MCGOWIN NORTH SUBDIVISION, UNIT THREE

APPLICATION NUMBER 2 DATE April 4, 2019

REQUEST Subdivision

DETAIL SITE PLAN

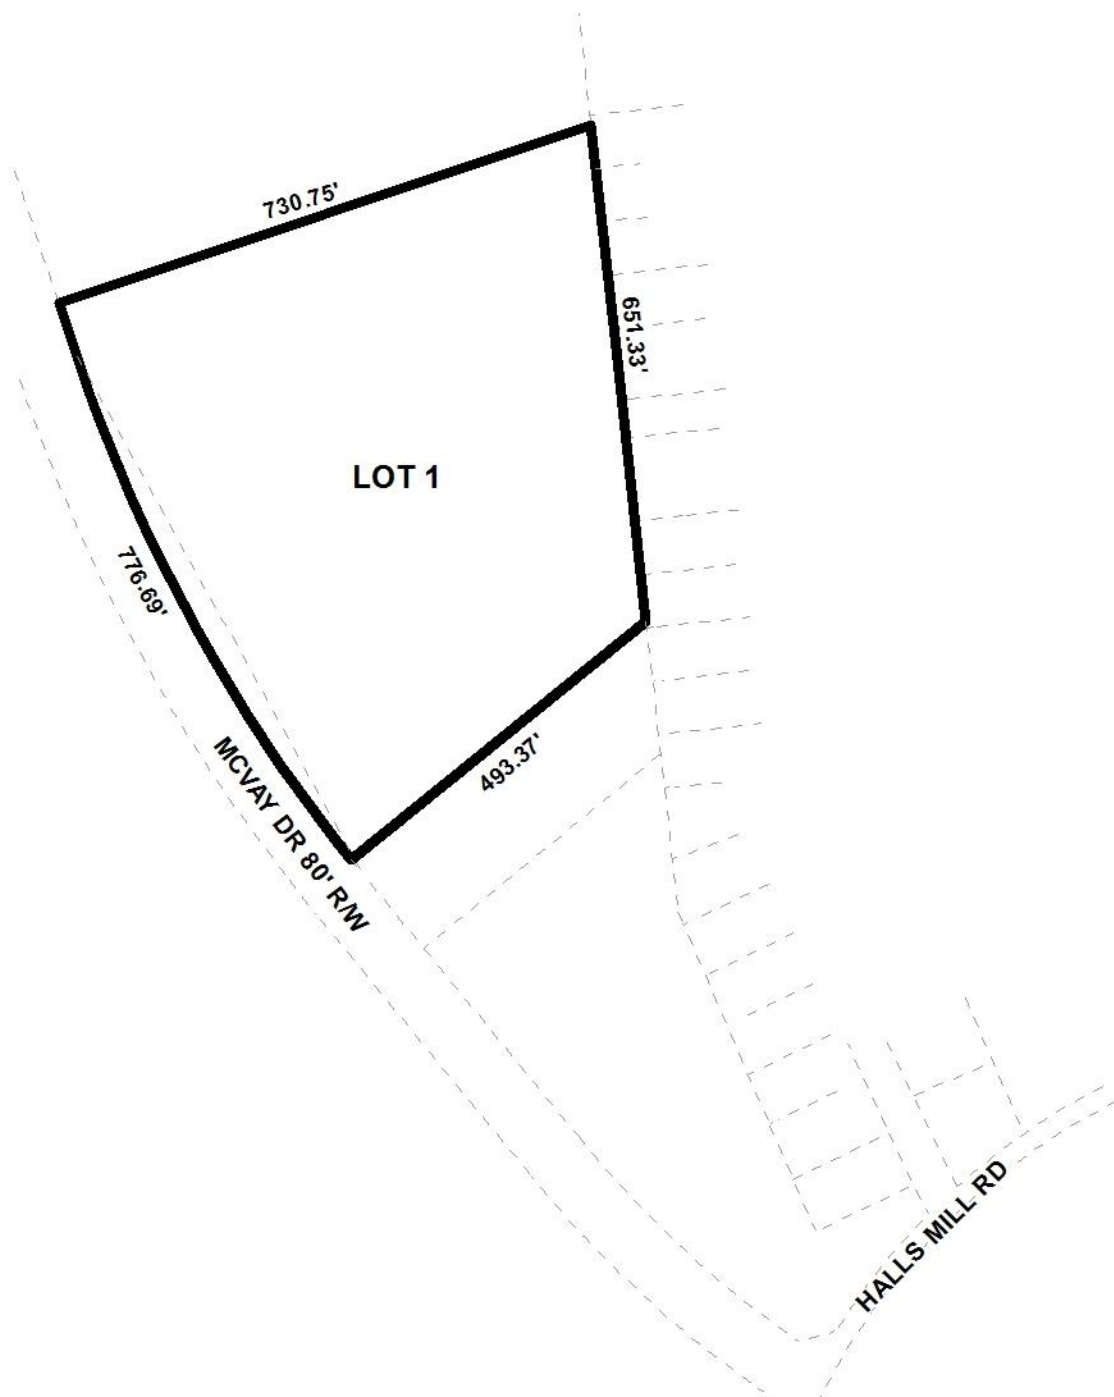
- B. Add legible street and street names to the vicinity map.
- C. Clarify the distance label for the eastern leg of the proposed subdivision boundary. It appears to be less than the distance listed with the record and calculated bearings - 1031.38'.

The site has frontage on McVay Drive North. The preliminary plat indicates the right-of-way width of McVay Drive North to be 80'. This right-of-way is sufficient and if approved, should be

retained on the Final Plat. A 25' minimum building setback line is not indicated along McVay Drive North. If approved, the Final Plat should be revised to indicate the required setback. As per the Traffic Engineering comments, the lot is limited to two curb cuts with size, location and design to be approved by Traffic Engineering and conform to AASHTO standards. Any new parking, including ADA handicap spaces, shall meet the minimum standards as defined in Section 64-6 of the City's Zoning Ordinance.

As on the preliminary plat, the lot size label should be retained in both square feet and acres on the Final Plat, or a table should be furnished on the Final Plat providing the same information. No easements are indicated on the preliminary plat. If any easements are recorded on the site they should be indicated and labeled on the Final Plat, and a note should be placed on the Final Plat stating that no structure may be placed or constructed within any easement.

- 1) retention of the current right-of-way widths of McVay Drive North on the Final Plat;
- 2) revision of the plat to illustrate the 25' minimum building setback line along McVay Drive North;

- 3) retention of the lot size in both square feet and acres, or the furnishing of a table on the Final Plat providing the same information;
- 4) placement of a note on the Final Plat stating that no structure may be constructed or placed within any easement (if applicable);
